Architect's Supplemental Instructions

PROJECT (Name and address):
New Offices for Hidalgo County Pct
2 and other County Offices
Pharr, Texas

**ARCHITECT'S SUPPLEMENTAL
INSTRUCTION NO:** 014

Work Changes Proposal Request

BLDG. 'A'
CONFERENCE/COMMISSIONER

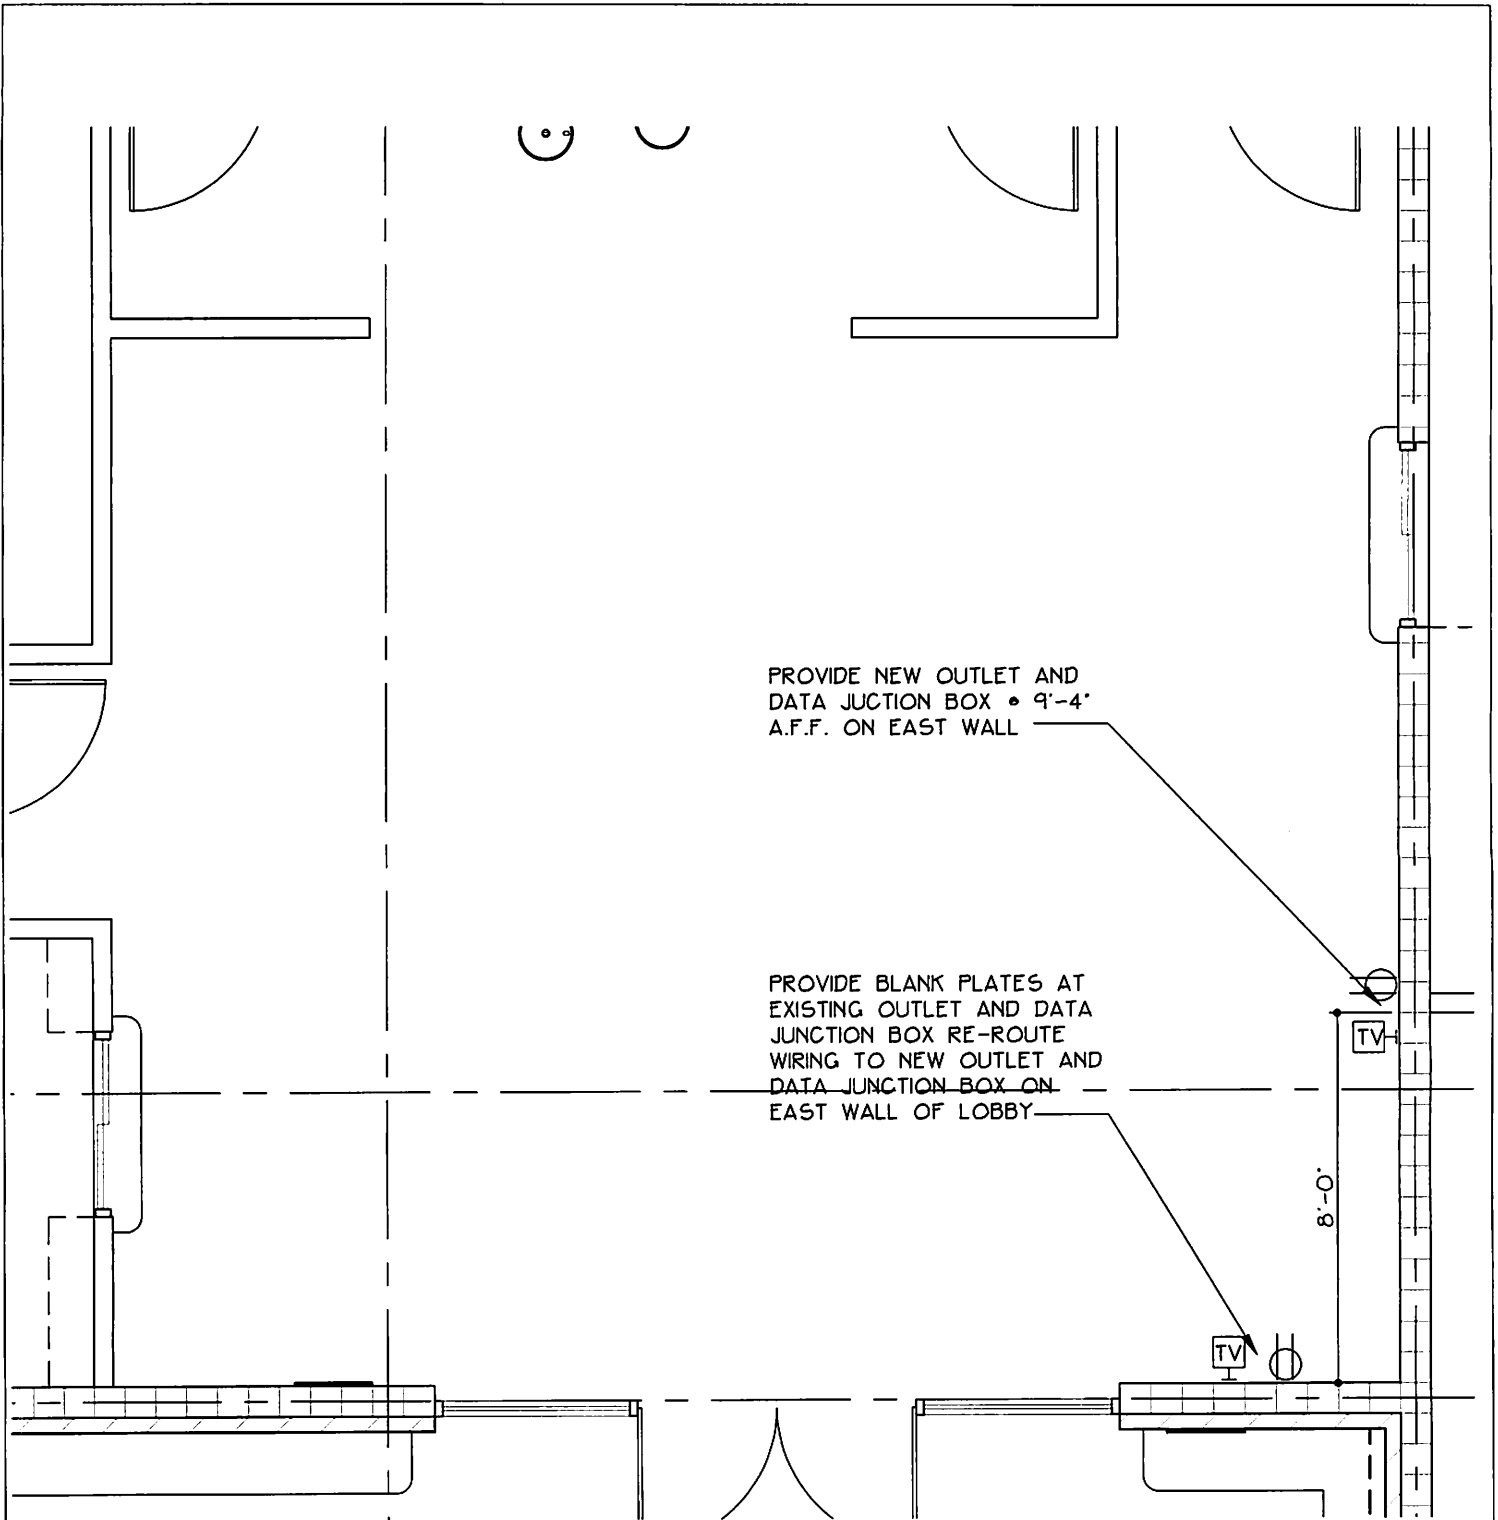
CONFERENCE
103
PROVIDE CARPET IN LIEU
OF VCT • ROOM 103

PROVIDE CARPET FLOORING IN
LIEU OF V.C.T. • ROOMS 103
+ 106. REFER ATTACHED
CARPET SPECIFICATION. PROVIDE
SAMPLE ASAP FOR COLOR
SELECTION

COMMISSIONER
106
PROVIDE CARPET IN LIEU
OF VCT • ROOM 106

BLDG. 'B+C'
HHS LOBBY RESTROOMS

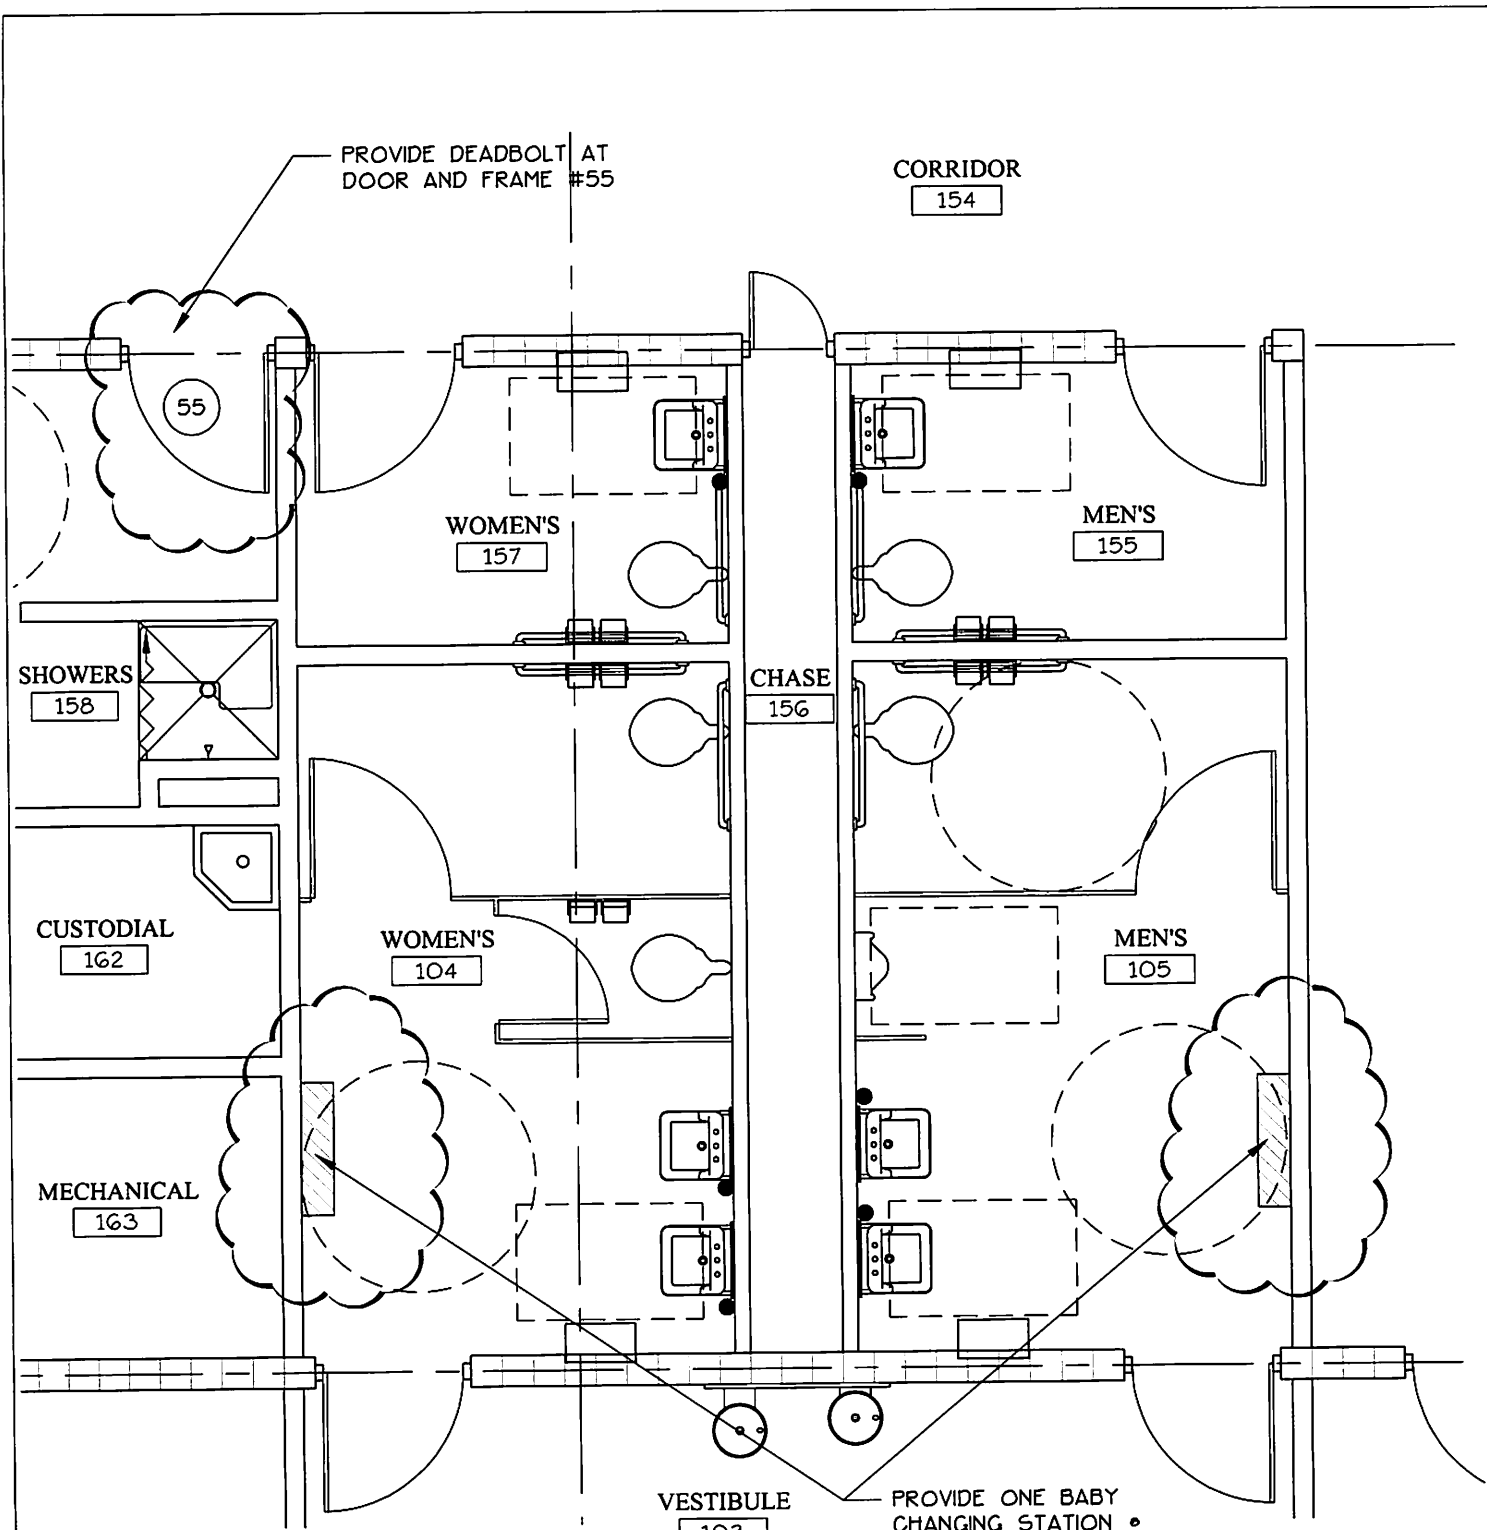
PROVIDE NEW OUTLET AND
DATA JUNCTION BOX • 9'-4"
A.F.F. ON EAST WALL

PROVIDE BLANK PLATES AT
EXISTING OUTLET AND DATA
JUNCTION BOX RE-ROUTE
WIRING TO NEW OUTLET AND
DATA JUNCTION BOX ON
EAST WALL OF LOBBY

BLDG. 'B+C'
HHS LOBBY RESTROOMS

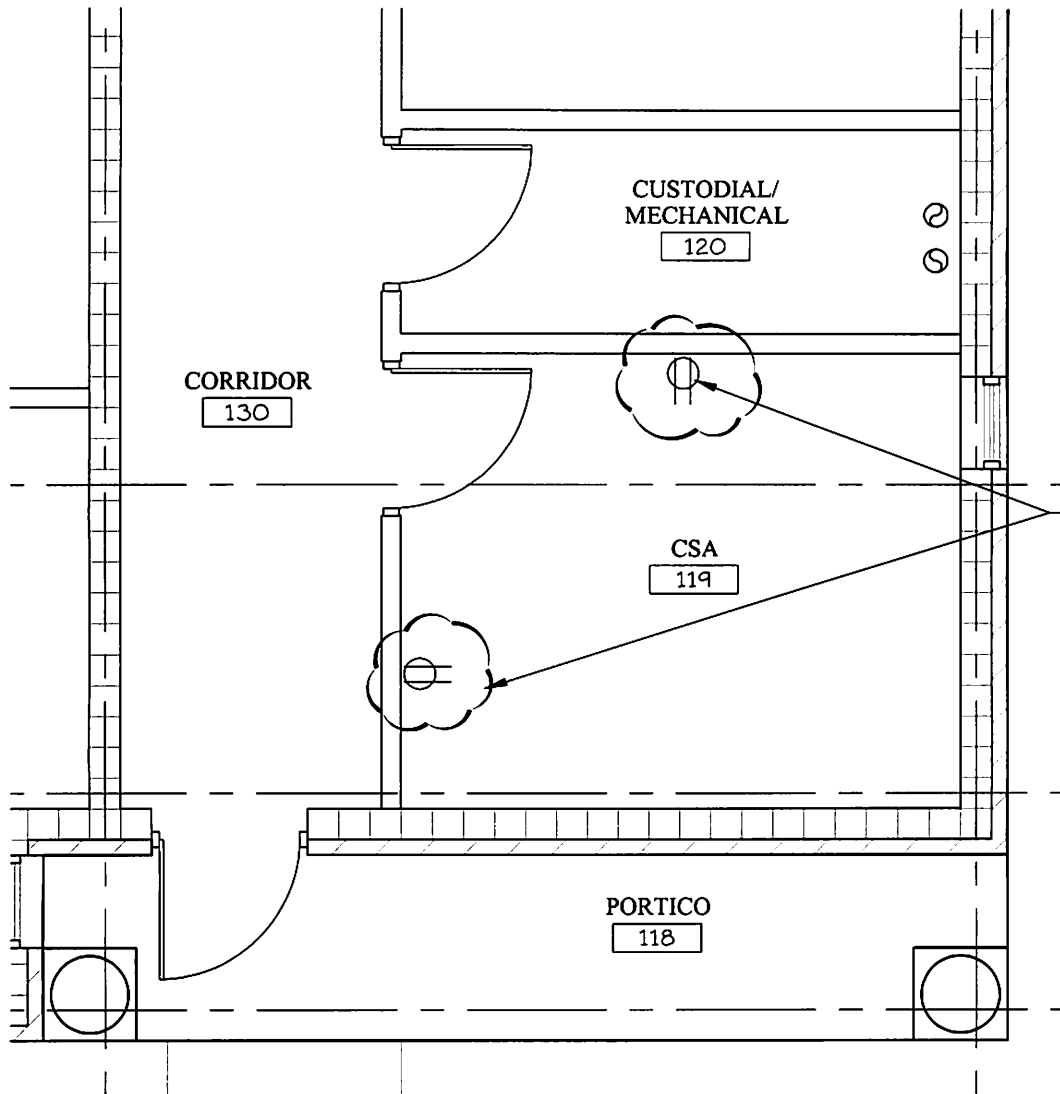
PROVIDE ONE BABY CHANGING STATION • ROOMS 172 + 174 AS MANUFACTURED BY BOBRICK. MODEL #KB200-00

BLDG. 'B+C'
HHS C.S.A. 119
SCALE: 1/4" = 1'-0"

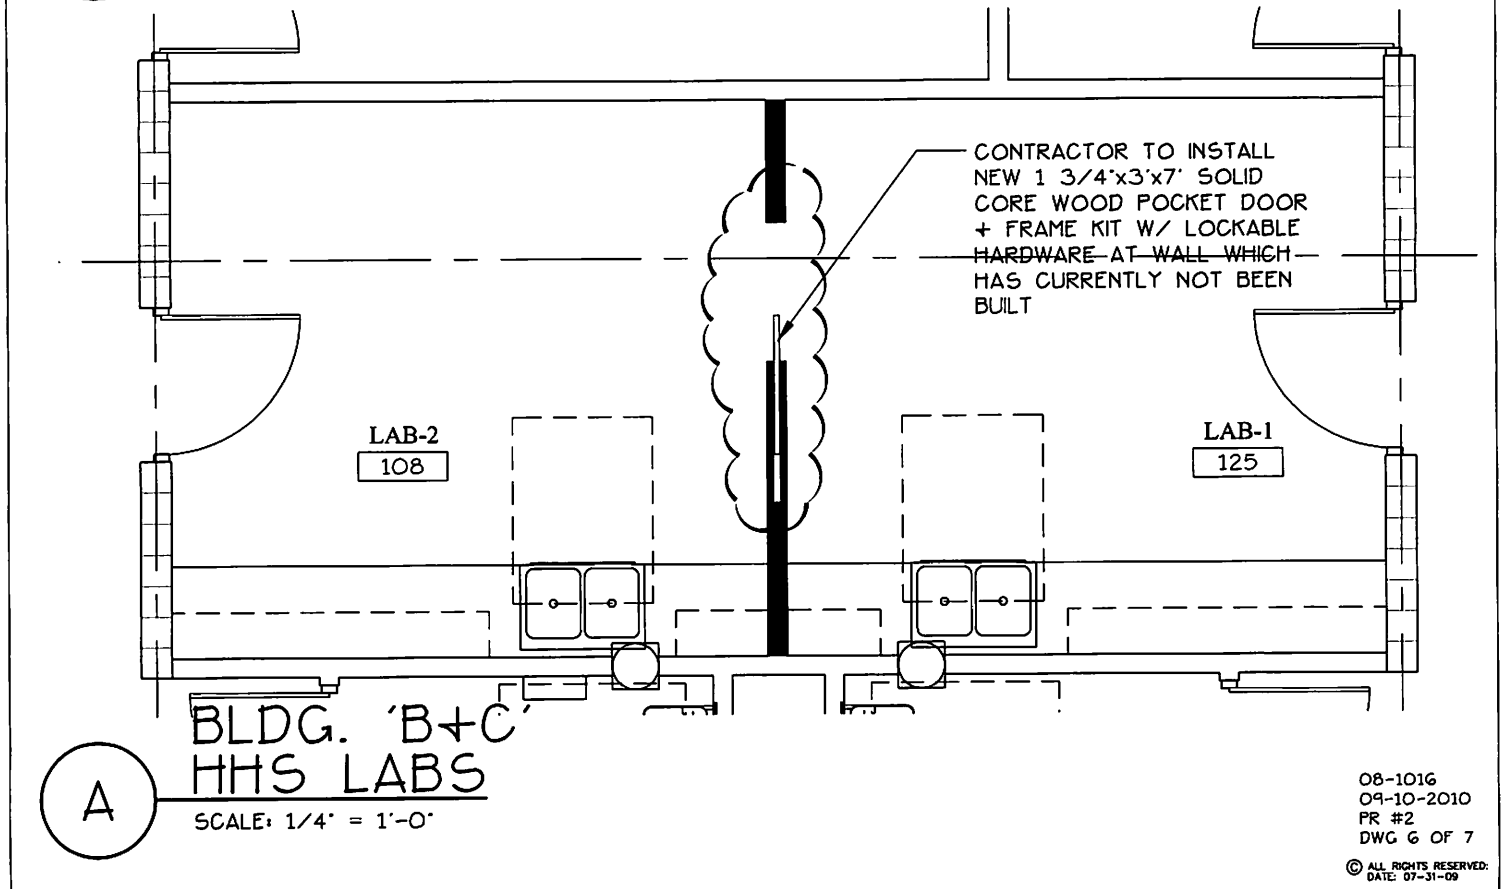
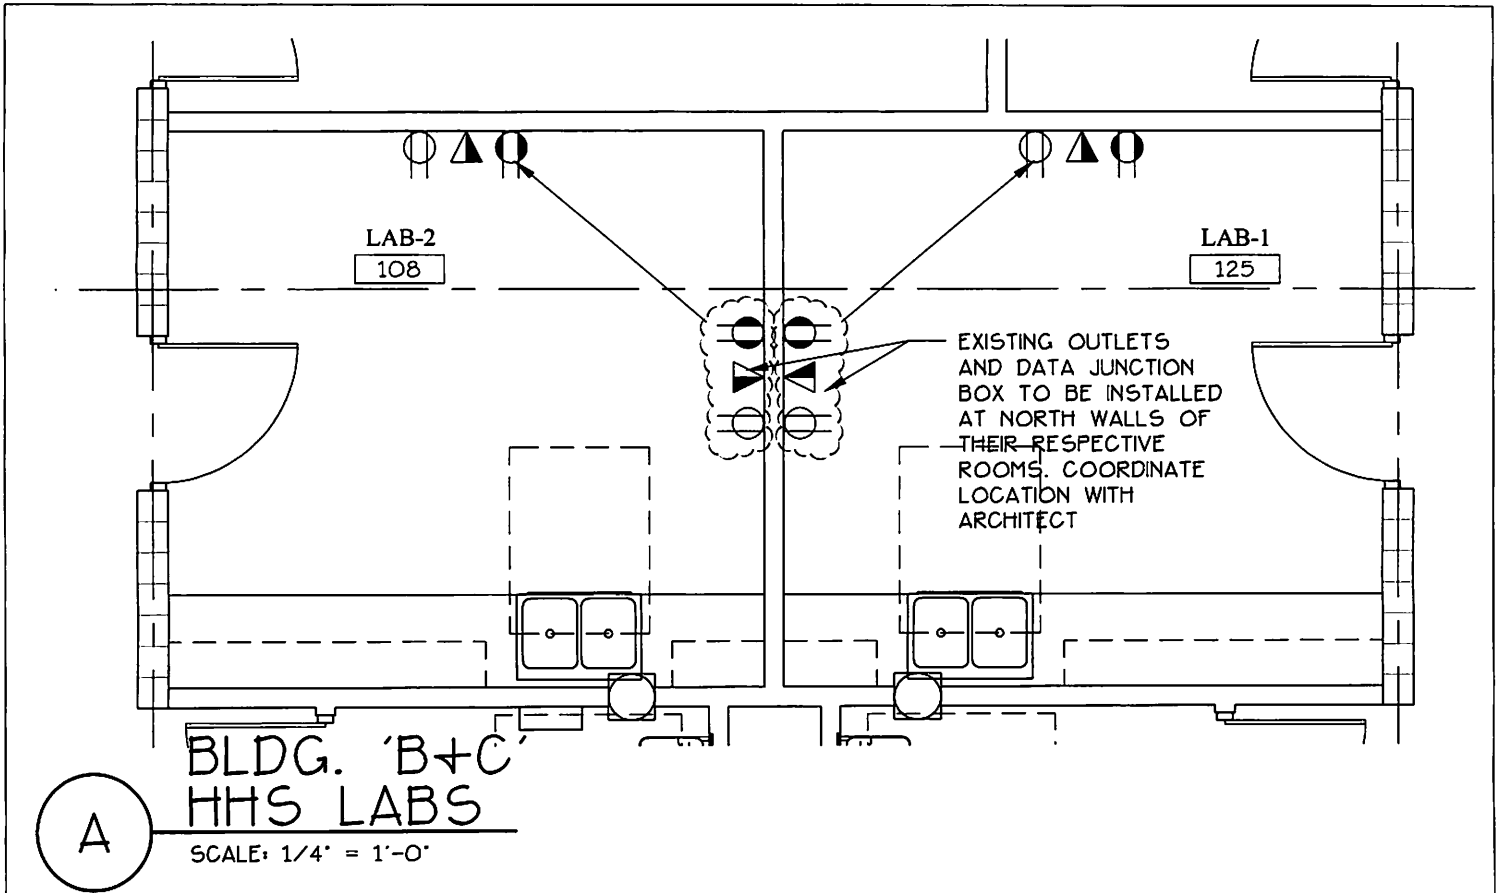
PROVIDE TWO NEW
OUTLETS TO
AVAILABLE SPARE
CIRCUIT ON PANEL
'PB'

BLDG. 'B+C'
HHS OFC. #3 + #4

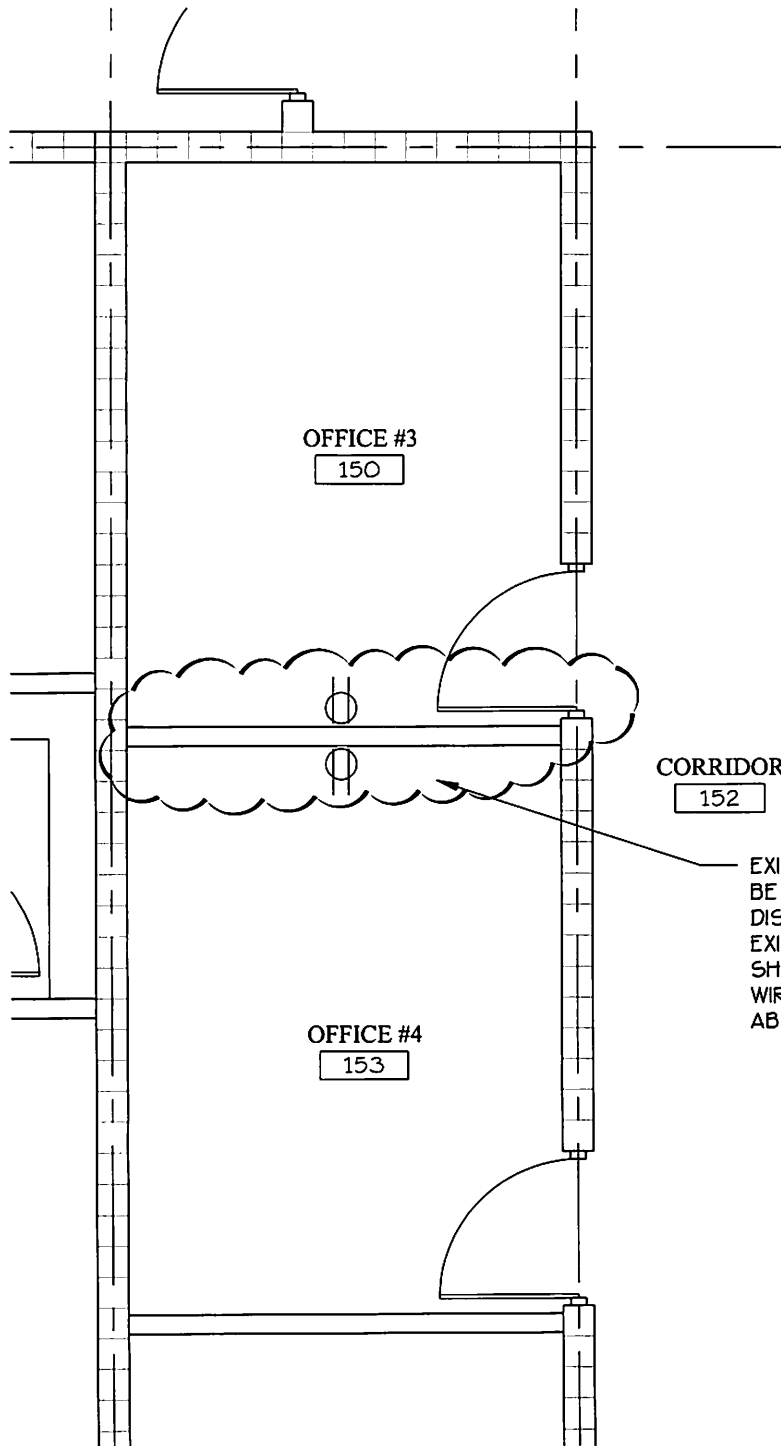
EXISTING WALL SHALL
BE REMOVED AND
DISPOSED OF.
EXISTING OUTLETS
SHALL BE REMOVED +
WIRING TERMINATED
ABOVE CEILING.

Monopole Tower Foundation
 Pharr, Texas

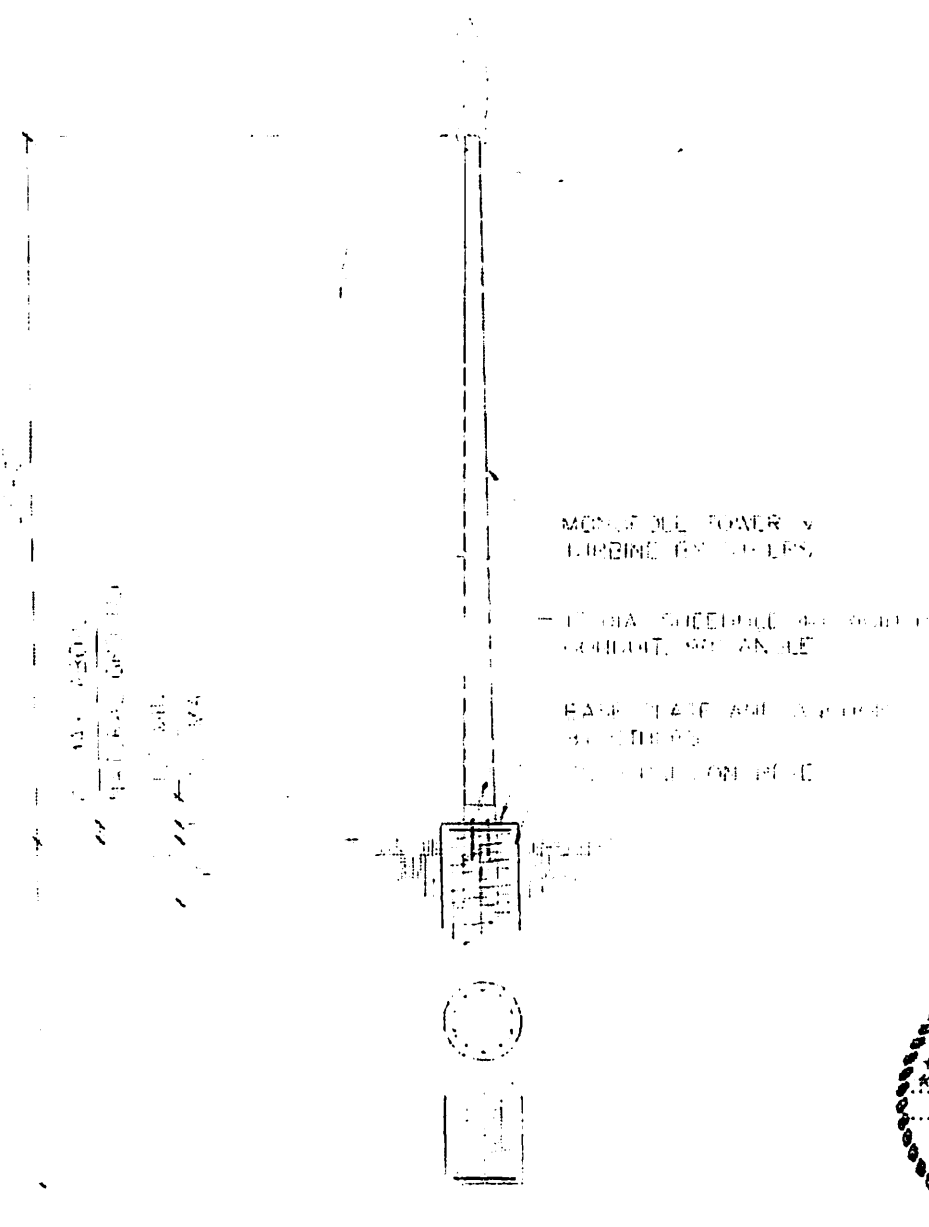
The wind turbine piers were designed to be centered in a mound of fill. Since the mounds have been eliminated, the structural engineer has rechecked the engineering design and determined that the piers now need to be five longer. each Two feet deeper and three feet higher with the pier tops set at one foot above the flood plain. The cost of adding five feet to all of the five piers is \$2402.00.
